Access Compliance Report

Public Rights-of-Way

(Curb Ramps)

Intersection ID: 10025367	Main Street: E_8TH_ST	Cross Street: N/A	Location: NE
ADA ID: 90B27174B8B7	Ramp Type: BlendTrans2	Initial Pass/Fail: Pass	Overall Compliance: No
Severity Score: 0			
Codes/Mitigation Info/Possible Solution		Field Measurements/Component Compliance

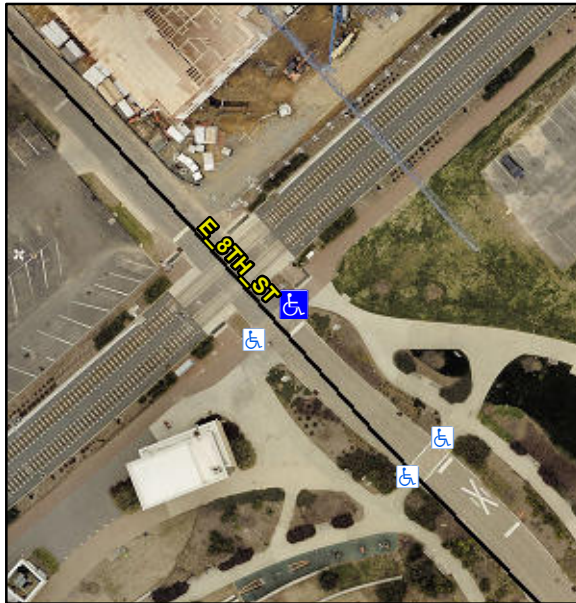
R304.5.3

Remove & Replace Gutter.
